**The Collection (Formerly Chevy Chase Center):
The Collection I, Site Plan Amendment No. 82001021H, and
The Collection II, Site Plan Amendment No. 82001013F**

Completed: 5.11.20

Site Plan Amendment No. 82001013F

Site Plan Amendment No. 82001021H

Figure 4 – Illustrative Public Use Space Modifications
82001021H (The Collection I; TSM Zone)

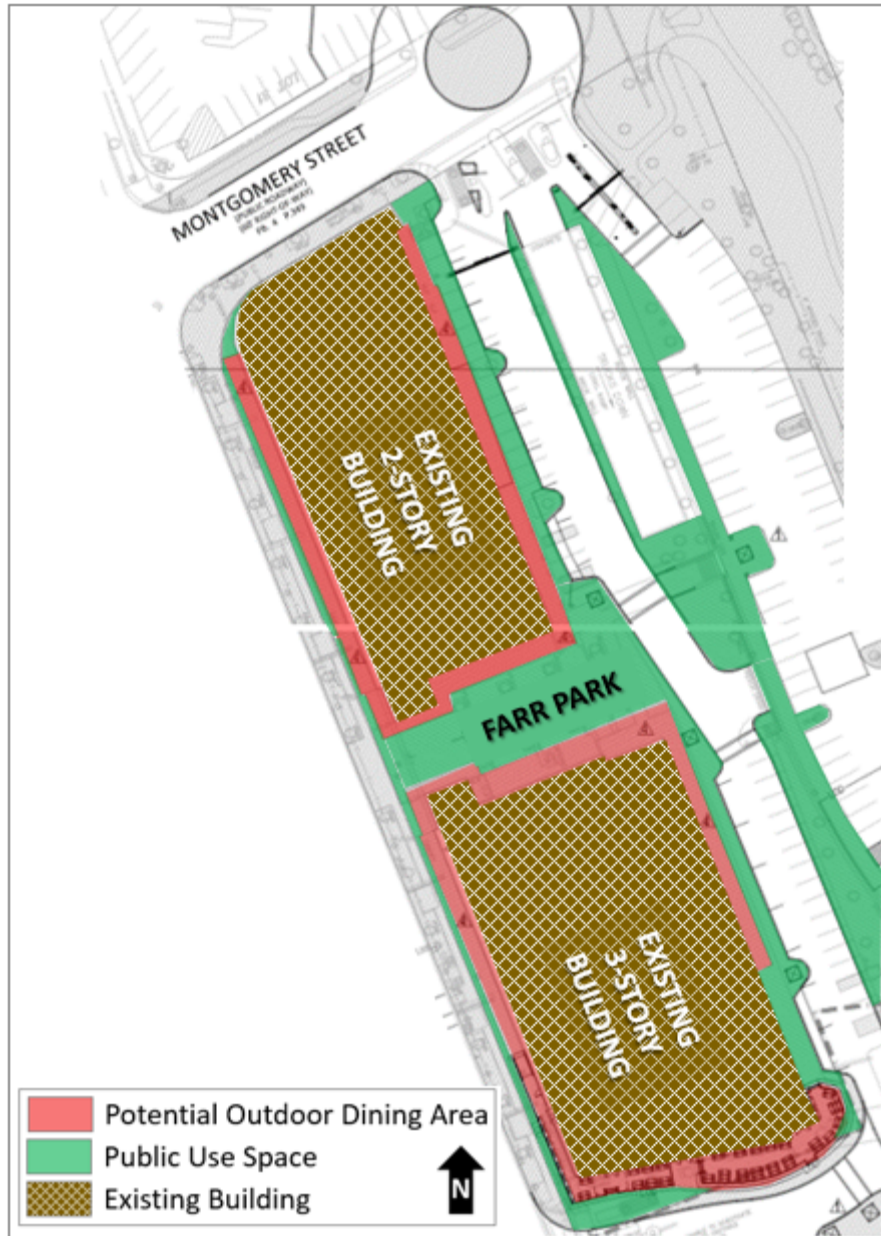
This expansion in private outdoor dining space necessitates a commensurate decrease in the amount of public use space on the Site to the minimum required by the respective zoning applicable to each Site Plan. The decrease in public use space is discussed below.

- **82001013F (The Collection II; CBD-1 Zone):** Decrease the public use space from 21.9% of the Site Area (32,848 square feet) to 20% of the Site area (30,000 square feet).
- Minor Adjustments in Commercial Space
 In order to accommodate potential restaurants within commercial spaces previously occupied by retail uses, the Applicant proposes to increase the total amount of restaurant square footage by reallocating space from “retail” to “restaurant uses.” To provide flexibility in future leasing, this request retains the original maximum density for retail uses and reallocates a portion of the retail density for restaurant use, as discussed in detail below.

Figure 6 – Wisconsin Avenue Outdoor Dining Space Expansion
82001021H (The Collection I; TSM Zone)
(Plan View)

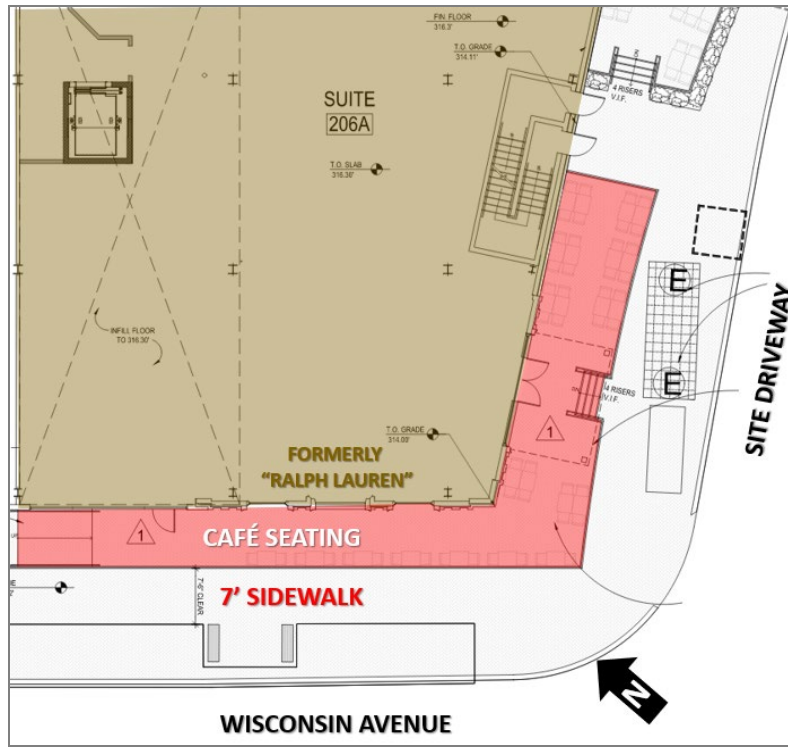
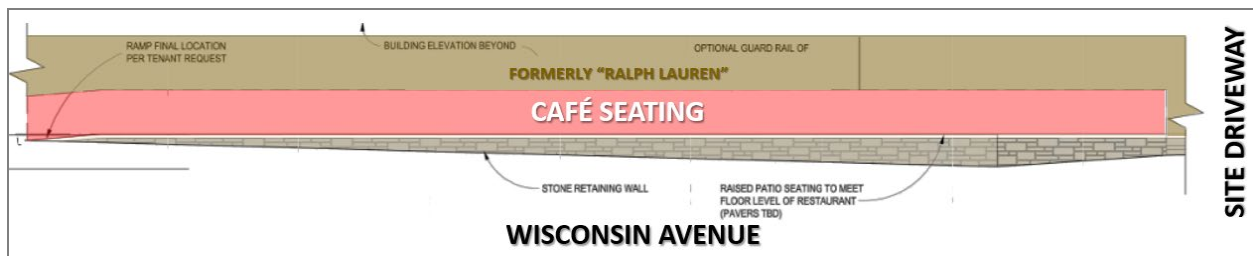
4. The Certified Site Plan must reflect a 7-foot-wide minimum clear pedestrian path width along Wisconsin Avenue and a minimum clear pedestrian path of 6 feet along all outdoor dining areas.

Where private dining is proposed along Wisconsin Avenue, a raised patio will be constructed between the existing building façade and adjacent public sidewalk (Figures 6 and 7). At a minimum, the adjacent public sidewalk will measure seven (7) feet wide between the tree panel and raised patio retaining wall. In addition to the construction of a raised patio, the expansion of the private dining space necessitates relocation of several large planters within the Site. As conditioned, the maximum limits of the outdoor dining area must be shown on the Certified Site Plan.

- Encroachment into Pedestrian Walkways
The community raised concerns about the potential for new outdoor dining areas to encroach into pedestrian walkways. In response to these concerns, and in accordance with the County standards, sidewalks adjacent to outdoor seating areas measure at least 6-feet in width. Additionally, Staff recommends conditions of approval that mandate a minimum width of 7-feet along Wisconsin Avenue and 15-feet at the narrowest point within Johnson Park.
